VENTURA UNIFIED SCHOOL DISTRICT

BID ADDENDUM NO. 1

ISSUED 3/21/2025

**PORTABLE TEAM ROOM
VENTURA HIGH SCHOOL
PROJECT NO. E12-25**

A-2.1

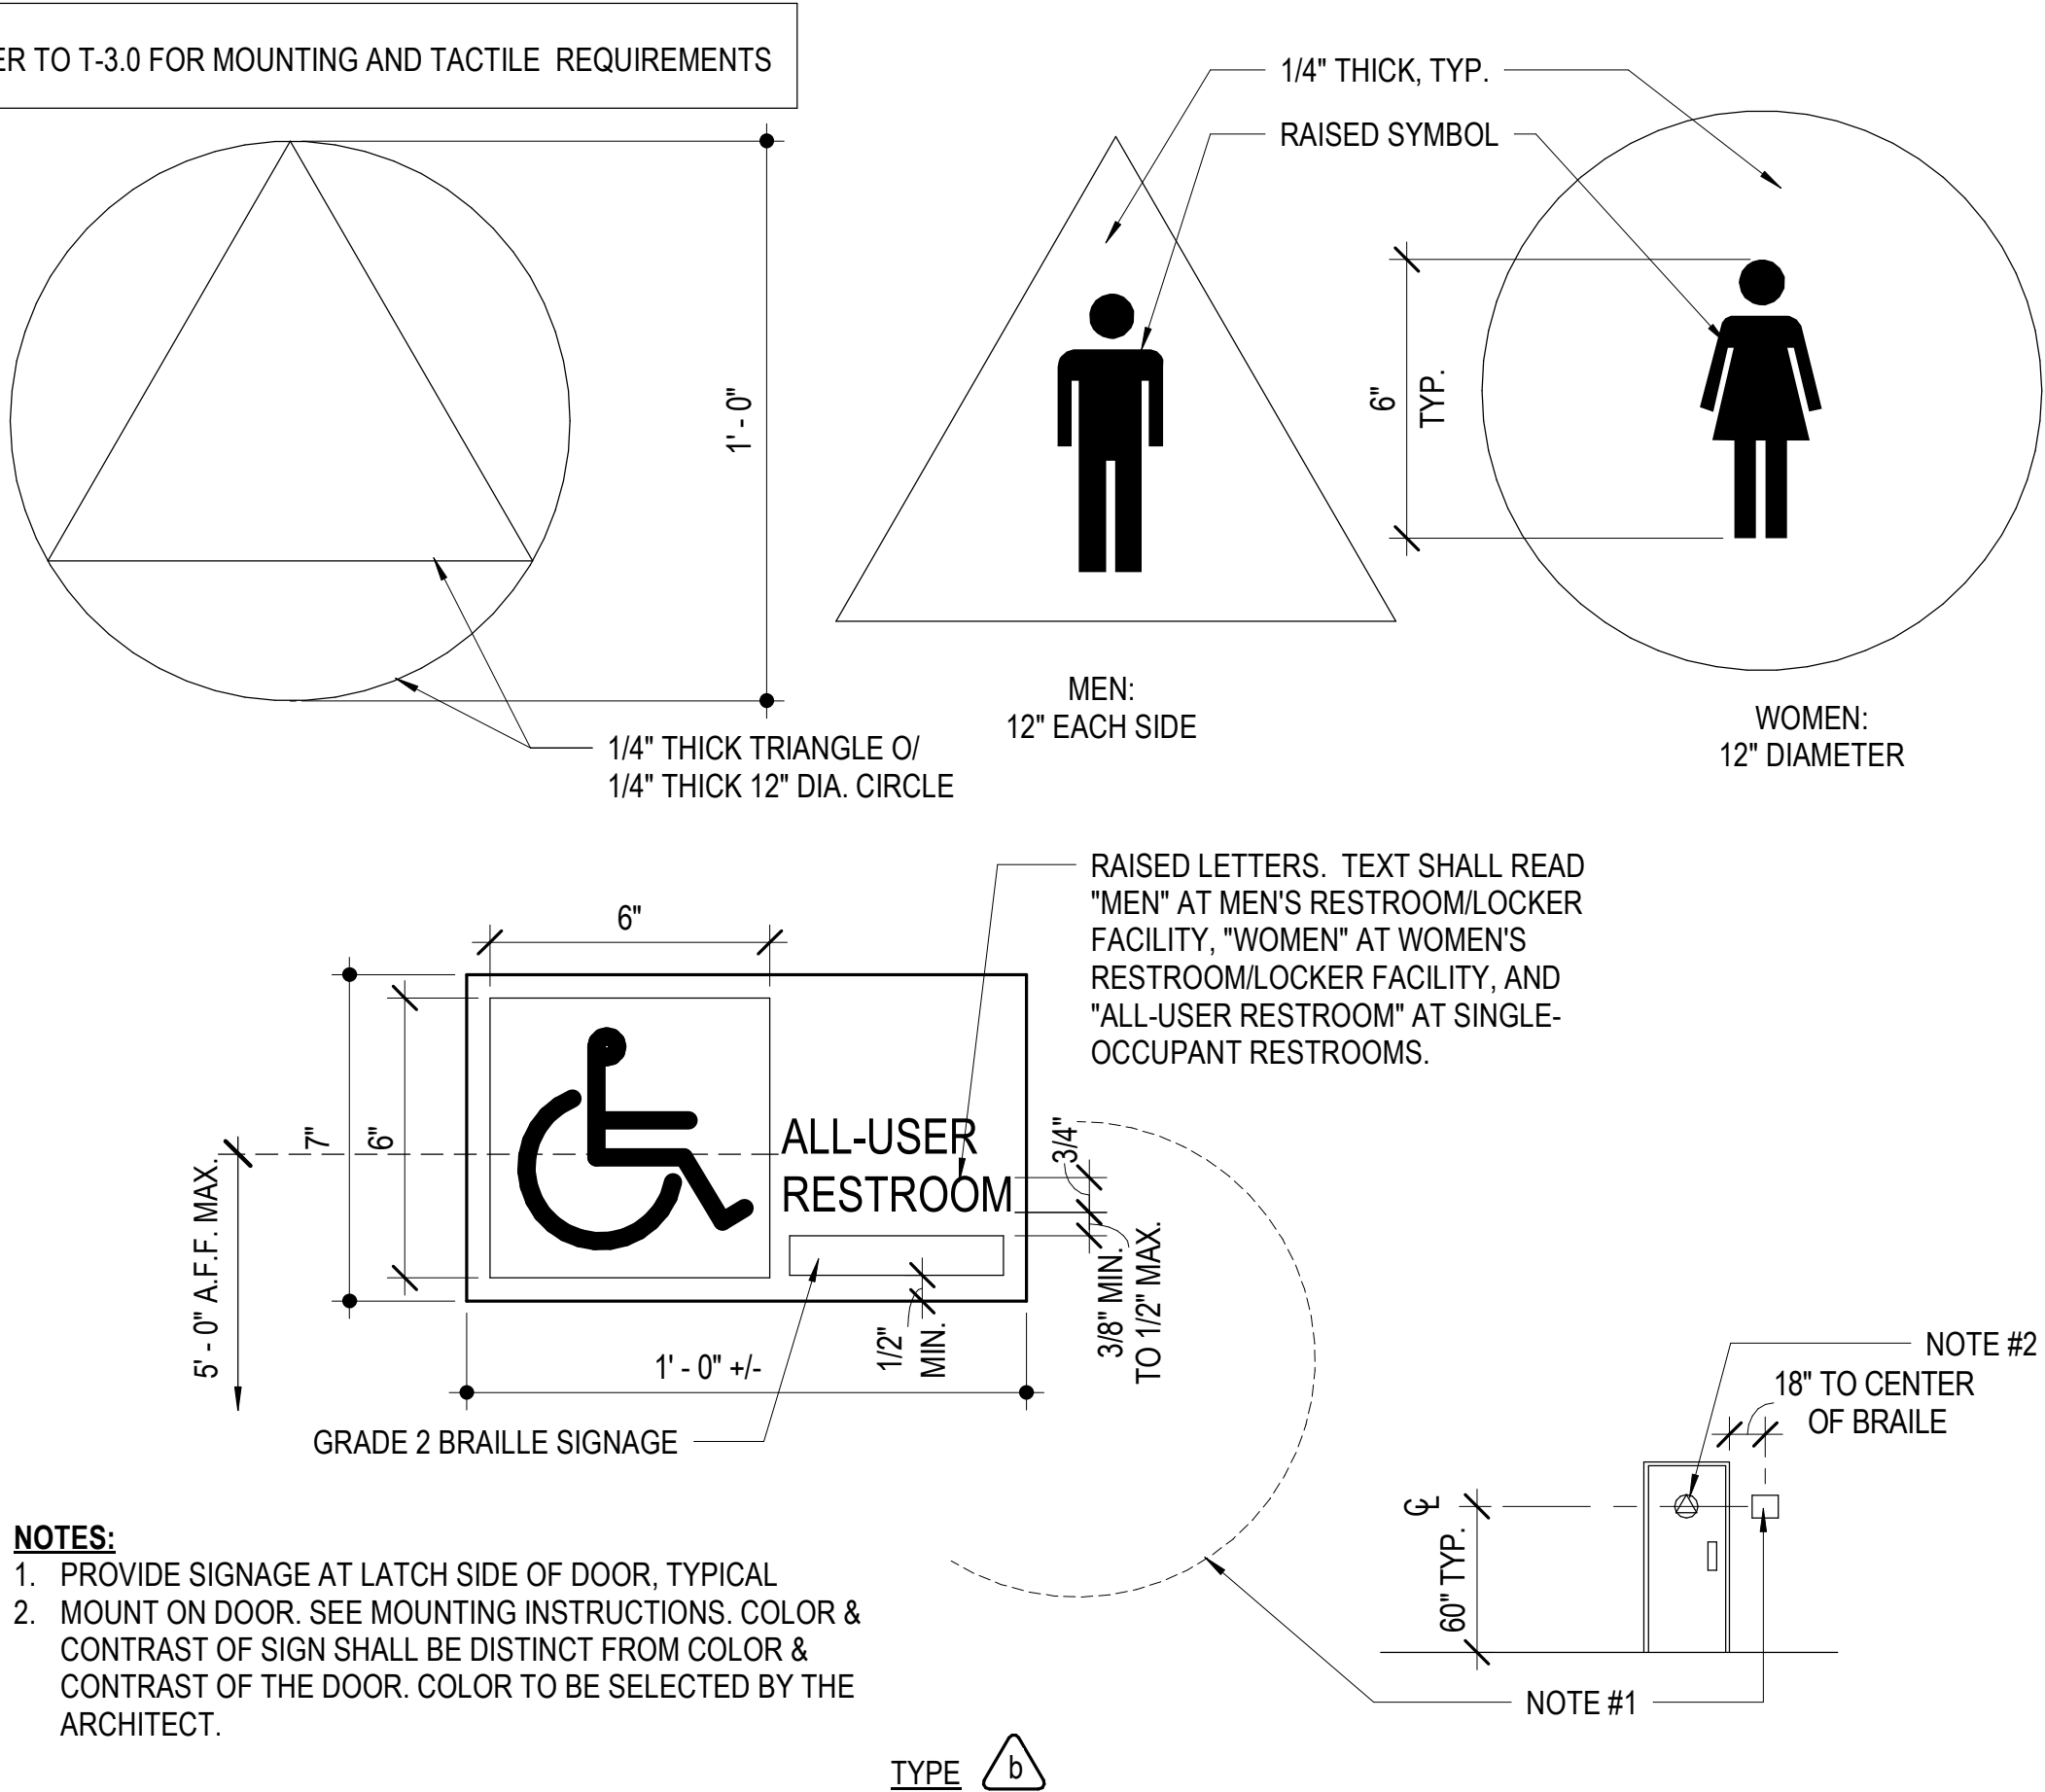
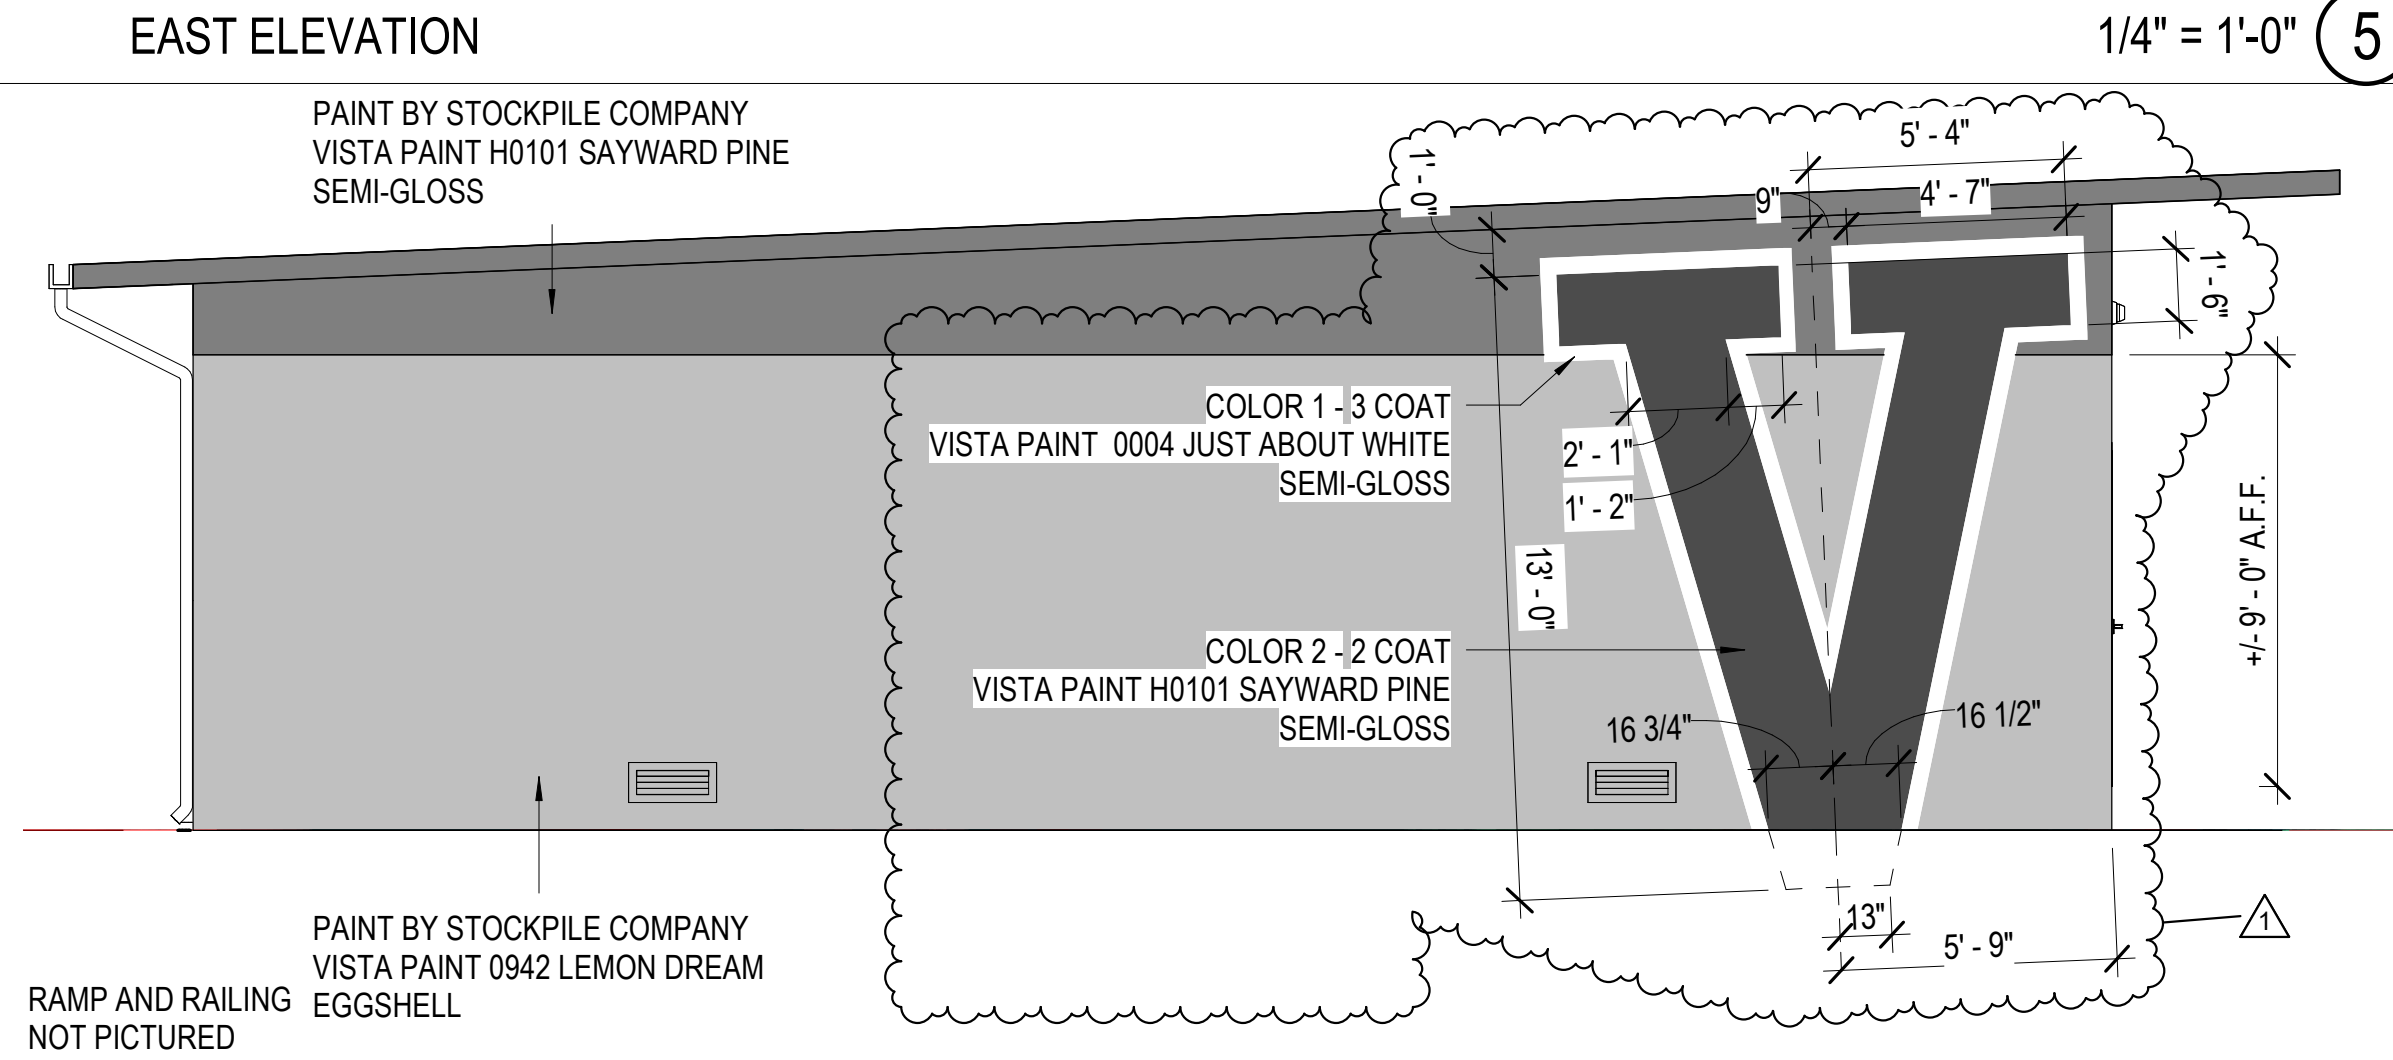
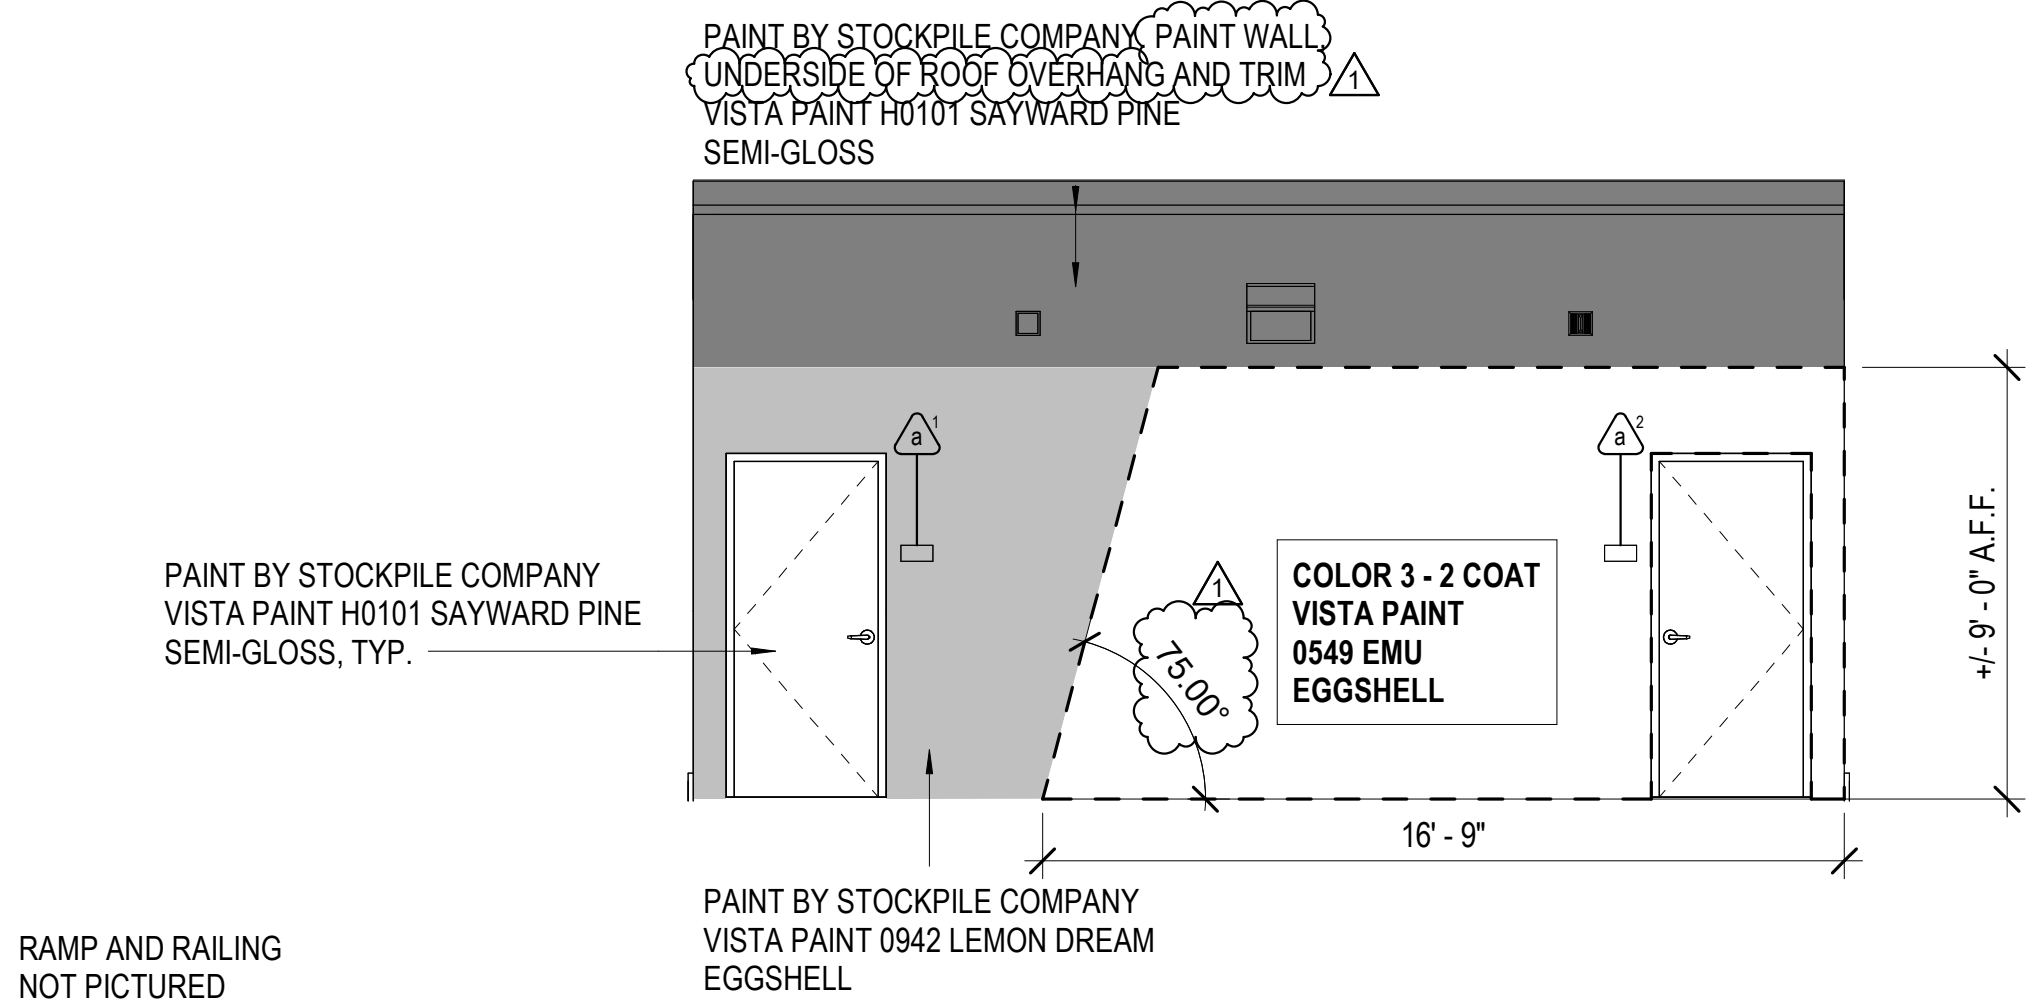
- Item 1 **Paint updates –**
A-2.1 – minor clarifications and adjustments and a new painted logo approach
- Item 2 **Accessible path updates –**
A-2.2 Included note for removal and reinstallation of existing bicycle parking.
Clarification of keynote 02-01.
- Item 3 **Electrical existing infrastructure updates –**
E-100, E-200 - Updated electrical site plan to reflect site infrastructure updates related to scoreboard project.
